RE: **PUBLIC Comments of the Minnesota Department of Commerce, Division of Energy Resources**
Xcel Energy 2023 Integrated Distribution Plan
Docket No. E002/M-23-452

In the Matter of Xcel Energy's 2023 Integrated Distribution Plan

PUBLIC Comments of the Minnesota Department of Commerce

Docket No. E002/M-23-452

Figure 1. Xcel Capital Profile Trend 2018–2028¹⁷

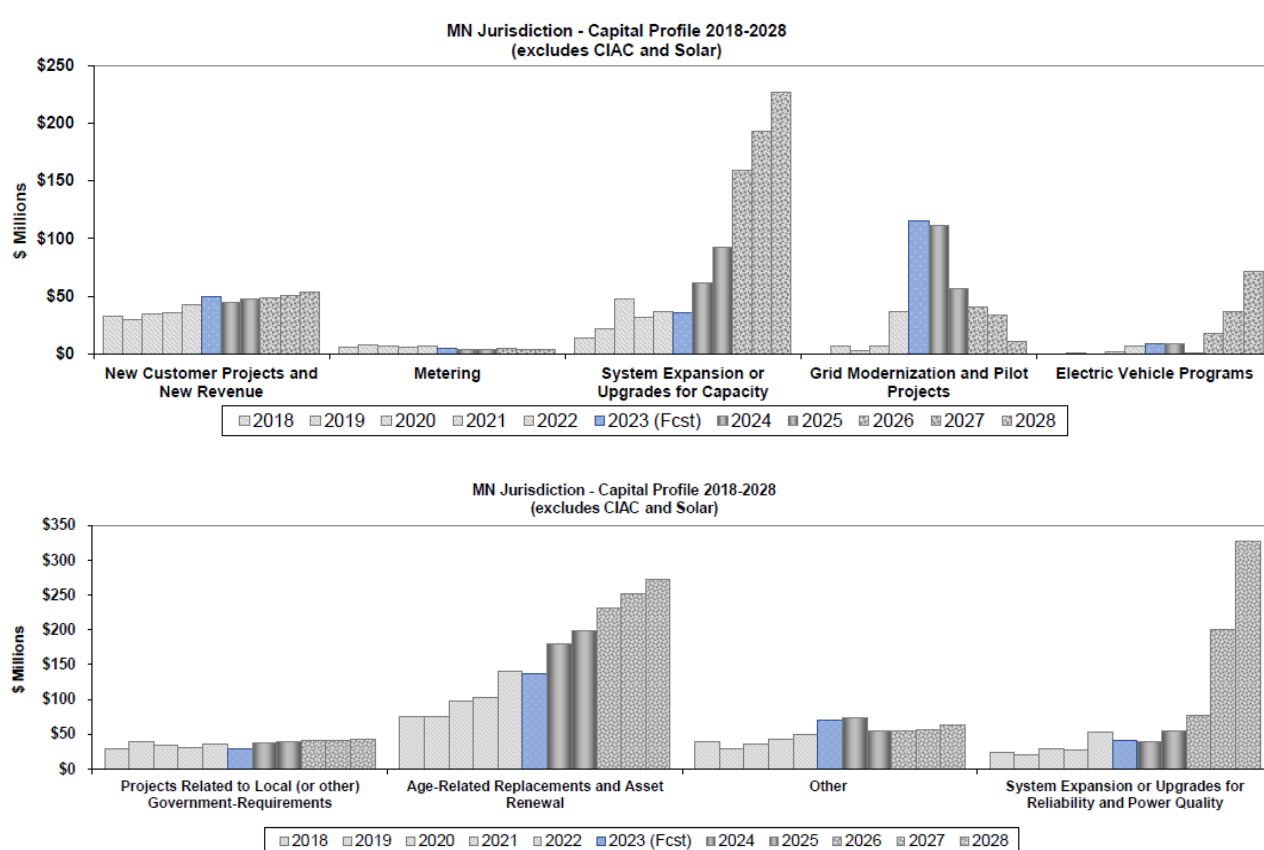
While the high-level budget summaries highlight the magnitude of total spending and increases in Xcel’s distribution system budget, the IDP includes additional detail on overall budget trends. The capital profile trend for annual costs from 2018 through 2028 provided in Attachment I, along with a brief description of cost drivers, illustrates the gradual and, at times, dramatic increases across multiple IDP Budget Categories (see Figure 1).

The list of capital projects in Attachment H, therefore, serves as the most detailed information in the IDP for stakeholders to understand what activities comprise Xcel's \$4.2 billion in total distribution system spending. In some IDP Budget Categories, the list identifies a significant number of specific projects and, in total, the budgets for those projects comprise a large share of the total spending in that Budget Category. Specifically, the "Age-Related Replacements and Asset Renewal" and "System Expansion or Upgrades for Capacity" Budget Categories provide the most project-specific detail. However, even for these Budget Categories, the majority of the total spending falls under the general categories of "blanket" and "program," providing limited insight into the underlying costs and the increases included in the five-year budget.

For example, in the "Age-Related Replacements and Asset Renewal" Budget Category, the largest category of the distribution system budget, Xcel has included \$1.1 billion in total spending from 2024 through 2028. Of this total, more than \$800 million (71 percent) falls under the general category of "program," and annual costs double from \$100 million in 2024 to nearly \$200 million in 2028.²³ In addition, nearly \$200 million (17 percent) in total spending through 2028 is identified as "blanket."²⁴ No further detail is provided regarding the costs associated with specific programs or the underlying assumptions that drive the increases. Department Table 4 below summarizes the budget for "Age-Related Replacements and Asset Renewal" from Xcel's Attachment H:

Figure 2. Cumulative Xcel Native Peak Load Growth vs Solar DER Growth for IDP Med Scenario

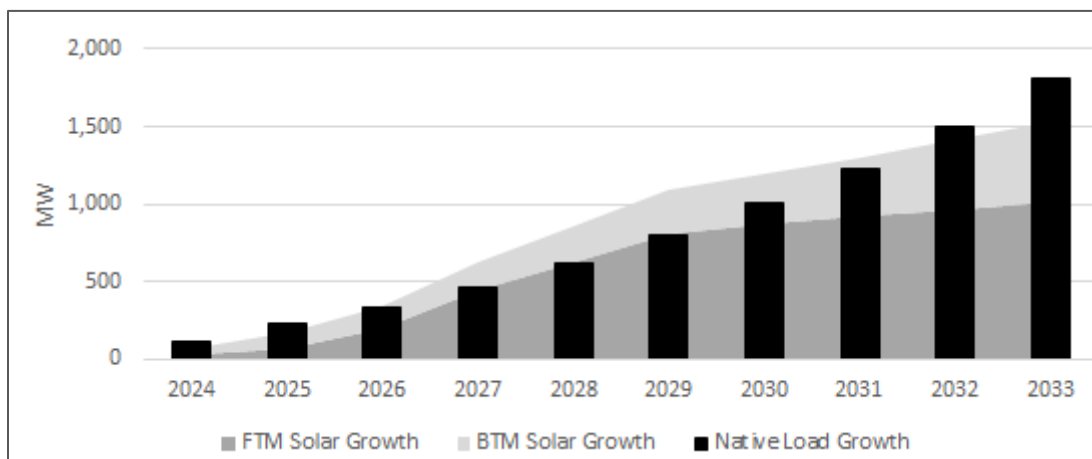
The balance between proactively planning for load growth and keeping rates low is a difficult process to navigate. This challenge is perhaps best illustrated by the push and pull of meeting the State’s goals for solar adoption. There are 261 projects on hold at capacity-constrained feeders, and 138 new projects that have applied to build solar projects on capacity-constrained feeders in the space of about

one-and-a-half years.⁴⁵ Traditionally, costs have been passed on to solar developers. Xcel discussed alternative cost allocation systems in Appendix I which could alleviate some of this stress. However, looking at the broader context of the distribution system reveals that the forecasted load growth is anticipated to surpass solar DER growth by 2032, as shown in Figure 2. In complex situations such as this, it is clear that solar developers will be subsidizing some added capacity benefits that will benefit ratepayers in the near term, raising cost allocation questions.

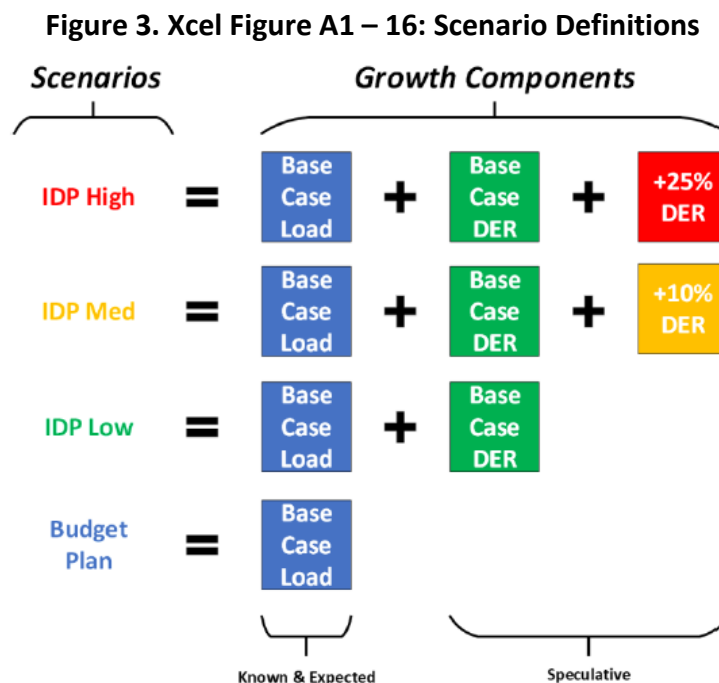
As noted above, Xcel’s budget does not generally correspond to accommodating DER adoption. As Xcel describes in its IDP, its budget plan scenario “represents the minimum desired funding level for capacity work to meet immediate distribution system capacity needs.”⁷⁷ The DER adoption scenarios then build from the budget plan with varying levels of DER adoption, namely the DER scenarios IDP

Low, IDP Med, and IDP High. Xcel provides a useful illustration to clarify this distinction across forecast scenarios, which the Department provides in Figure 1, below, for clarity:
